Service Bulletin

Subject: Replace The Internal Transmission Wiring Harness and TCC Enable Solenoid Anytime The Transmission Is In For Service - Malfunction Indicator Lamp (MIL) With DTC P0741 Set and Harsh 1-2 Shift Vehicles Manufactured After 10/01/11

Models: 2012 Chevrolet Colorado, Express, Silverado
2012 GMC Canyon, Savana, Sierra
All Equipped with Automatic Transmission 4L60E (RPO M30). Built after 10/01/11

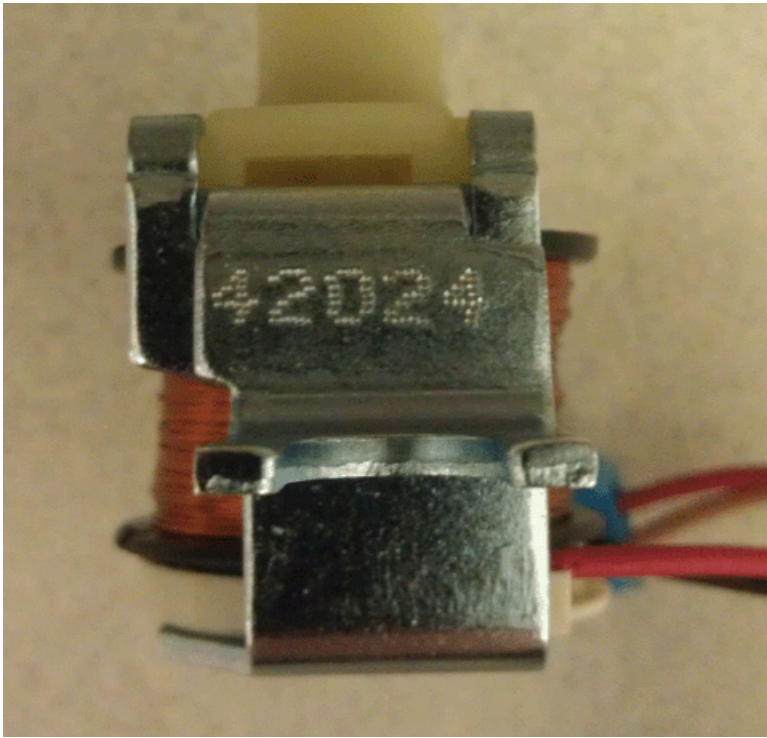
Note: To prevent multiple TCC Enable Solenoid and Wire Harness replacements check the five digit date code on the TCC Enable Solenoid body to see if it has been replaced.

The first digit (month of build) should be a 4 or higher or an alpha character. The second and third digits are the day of the month. The fourth digit should be a 2 or 3 (calendar year 2012, 2013).

The fifth digit (line of build) should be a numeric character typically a 3 or 4 Example: 42024 shown in the picture below was produced April 20, 2012 on line 4.

Any solenoid produced on or after April 17, 2012, date code of 4172# or greater, does not need to be replaced.

Important: Replace the TCC Enable Solenoid and Wire Harness part number 24237980 anytime repairs are being performed on the transmission on vehicles manufactured after 10/01/11.
